Proj. 2535

**RE: Marsville South Development - EIS Addendum/Response to GRCA
Comments**

Marsville South Development EIS (proj#2535)
 NRSI Response to GRCA Comments on the April 2022 NRSI EIS

Marsville South (Graham Property) Significance/Sensitivity and Proposed Development Constraints

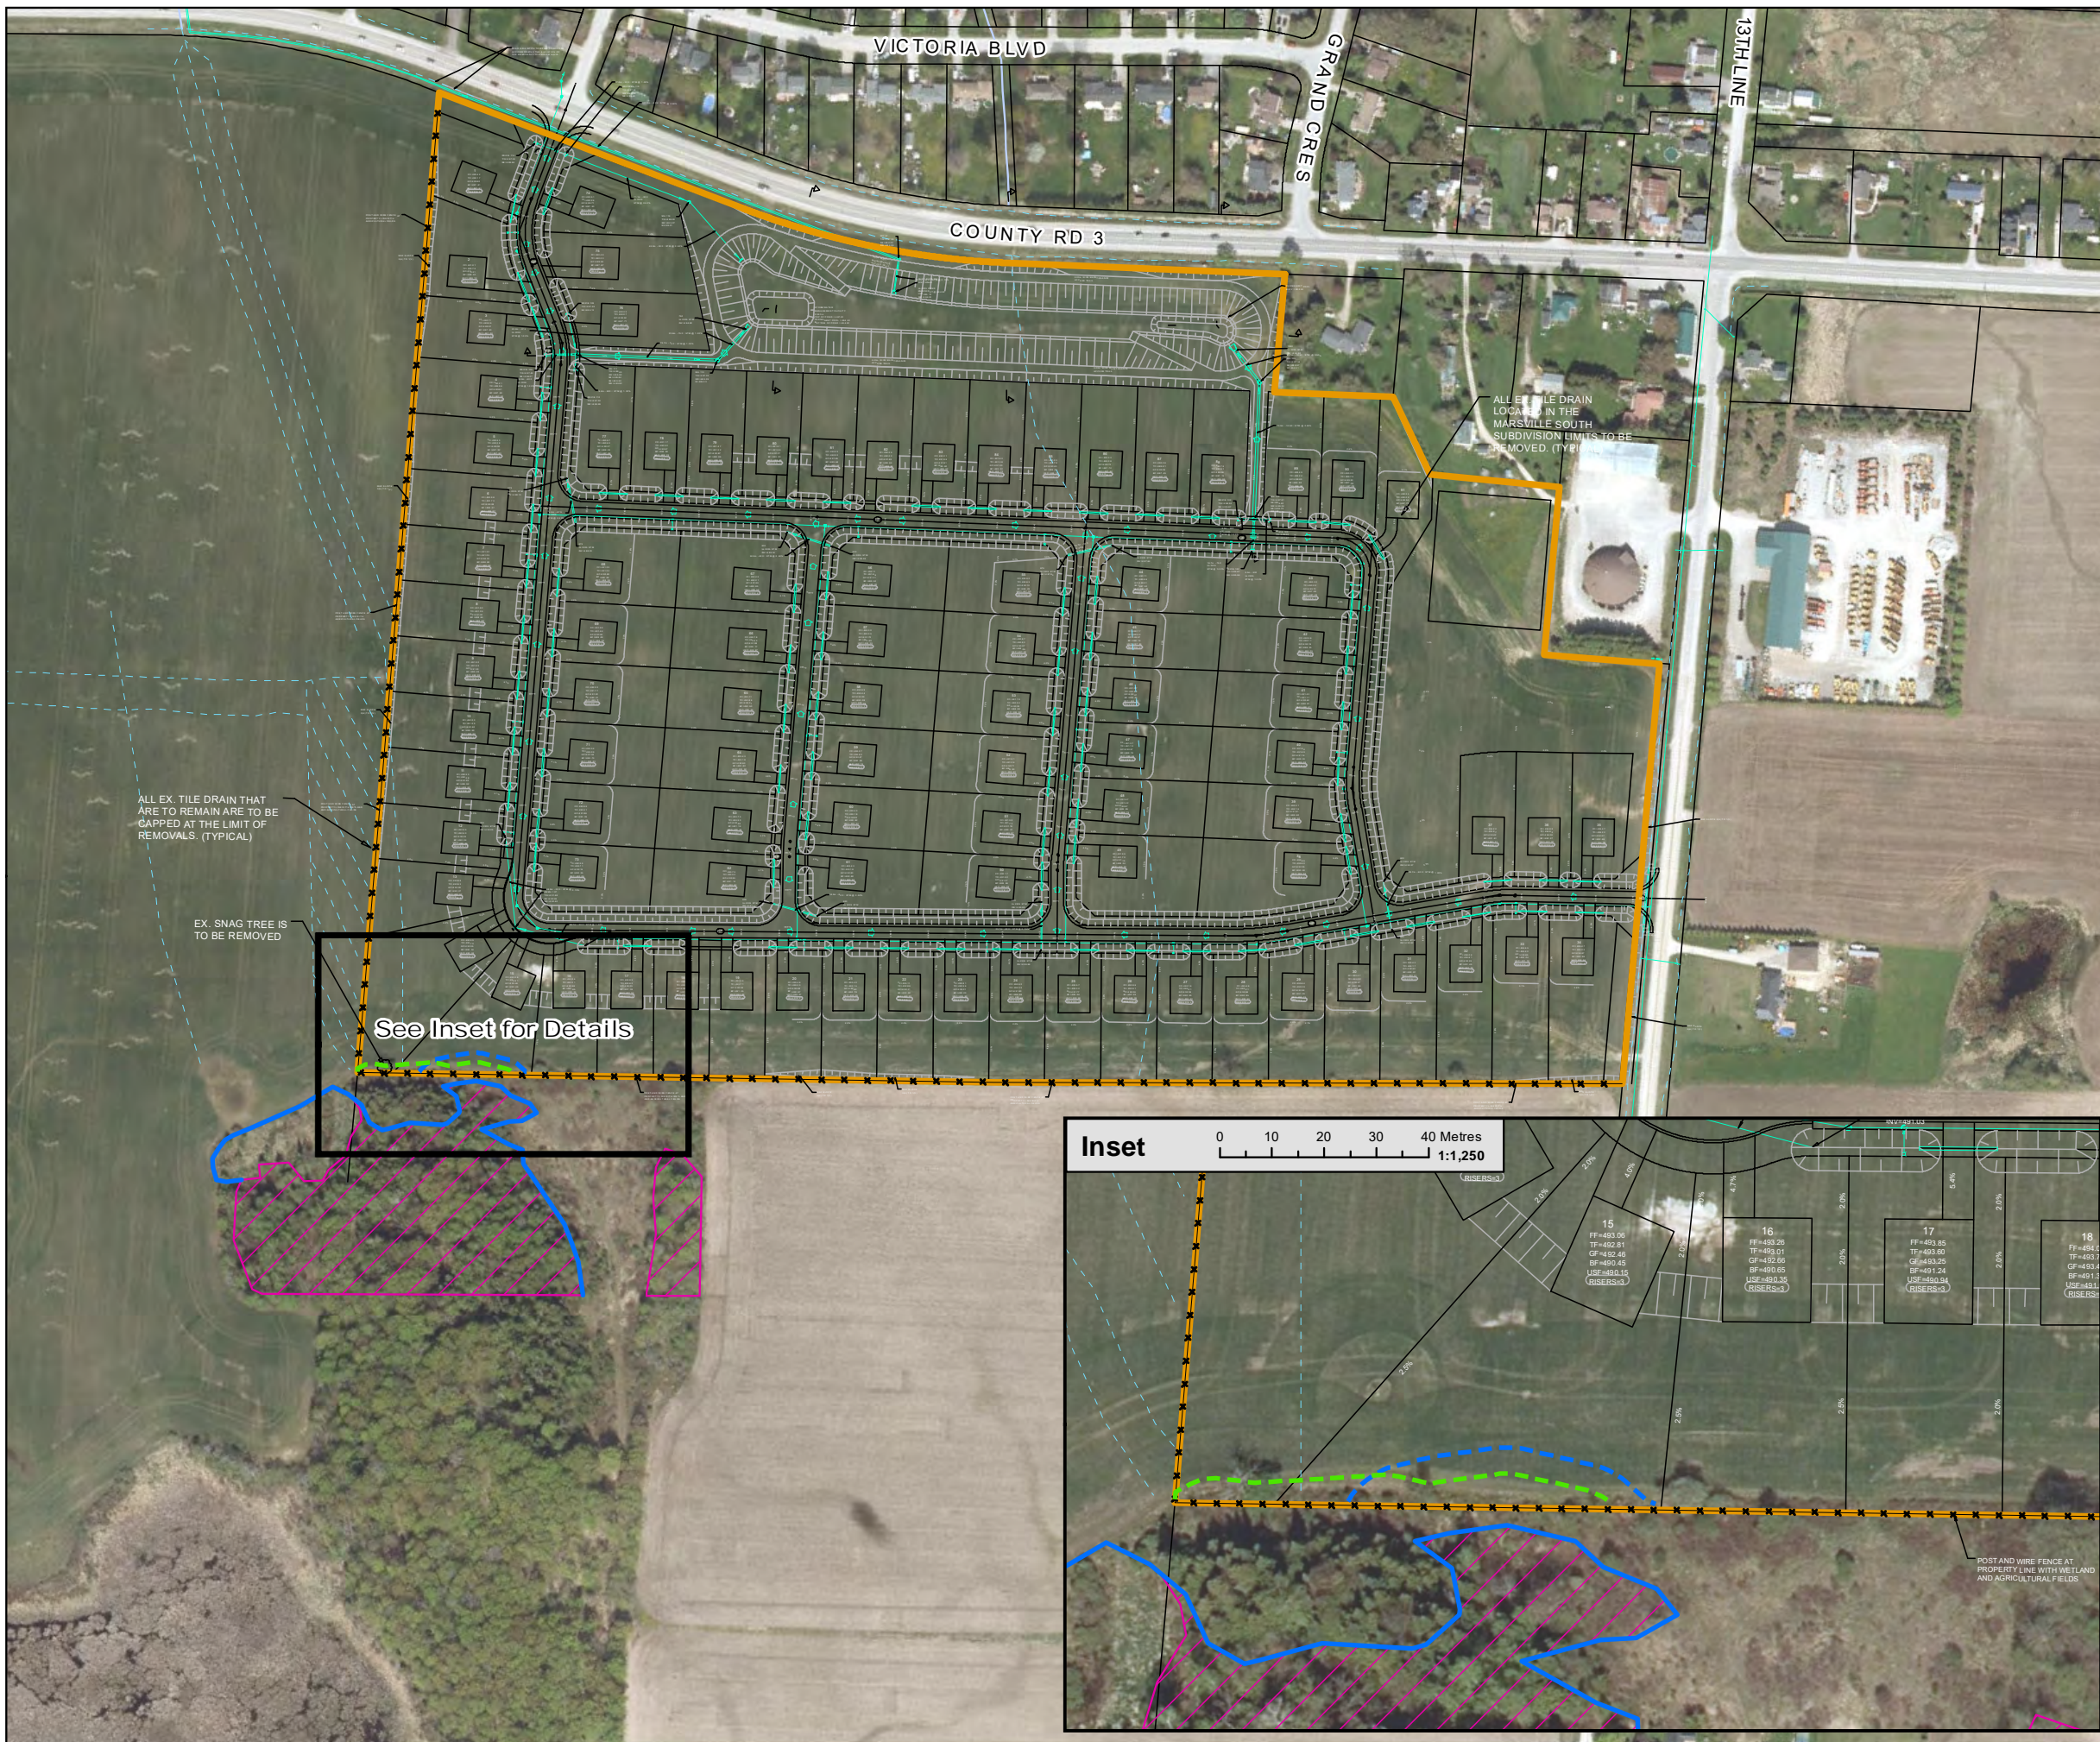
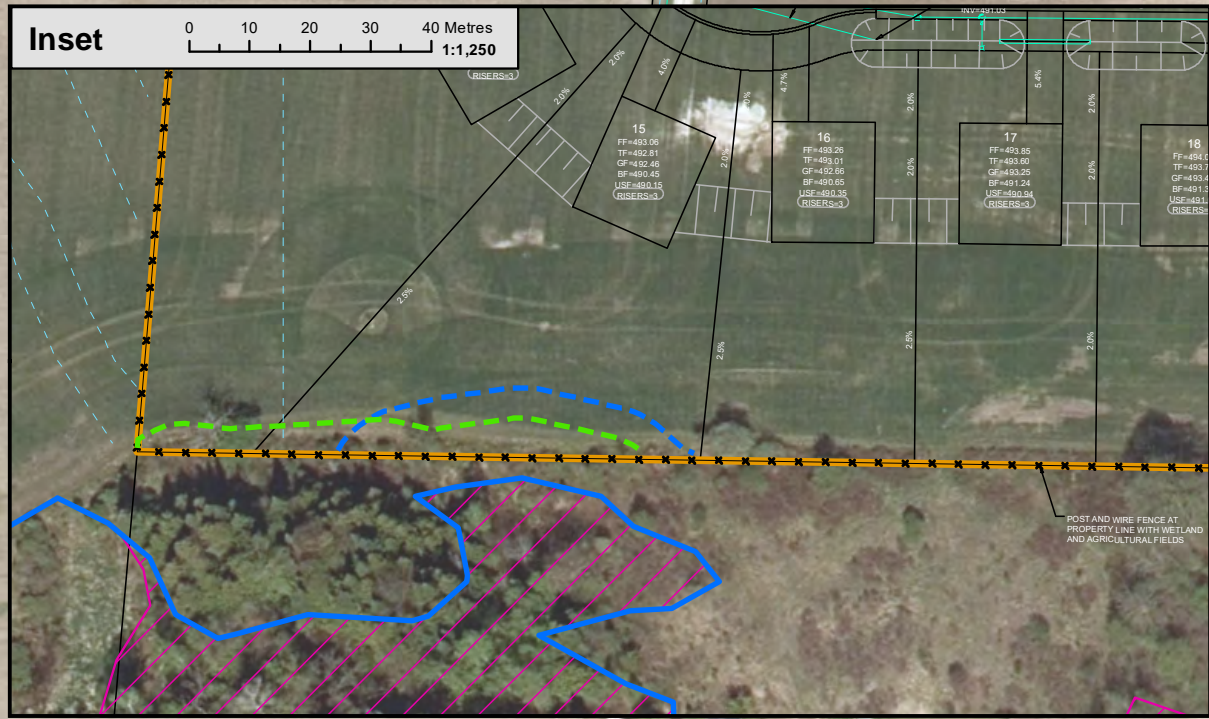
2	<p>A detailed grading plan showing existing and post-development contours within catchment 4000 is needed to fully assess impacts to the offsite wetland.</p>	<p>A detailed grading plan has now been provided for the site and is attached to the EIS addendum letter. The attached map provides an inset of the Catchment 4000 area in relation to the wetland. As shown on this map, grading will be gradual towards the wetland and will be located outside of the wetland buffer.</p>
3	<p>According to the EIS, the lands do not slope steeply toward the wetland. This is not sufficient rationale to support a 15 meter development setback from the wetland. A 30 meter setback from the offsite wetland is requested and would be consistent with subdivision applications in other portions of the watershed.</p>	<p>NRSI has provided a revised analysis of the buffer width along with additional mitigation measures such as large caliper tree plantings, topsoil amendments, and installation of a permanent fence at the rear lot line to prevent encroachment into the wetland.</p>

The rear of the lots abutting the wetland will be permanently fenced to further reduce encroachment into the feature. A post and wire fence is shown on the attached mapping.

A revised grading plan has been provided by GEI (2024b) and has been integrated into the natural heritage feature mapping prepared by NRSI (Map 3). As shown, the grading for the lots nearest to the wetland (Lots 14-16) is located towards the frontage on Street A and will not be located in close proximity to the wetland, woodlands or the respective buffers. Erosion and sediment control fencing will be located at the edge of the 15m wetland and 10m woodland buffers. The areas within the portion of these lots that are currently agricultural fields will be converted to turf grass during the construction period which is anticipated to reduce erosion and siltation into the wetland. Similarly, large caliber tree plantings will be provided at the rear of these lots to provide additional benefits such as shading, wildlife habitat, and increased absorption and transpiration of runoff, as described above.
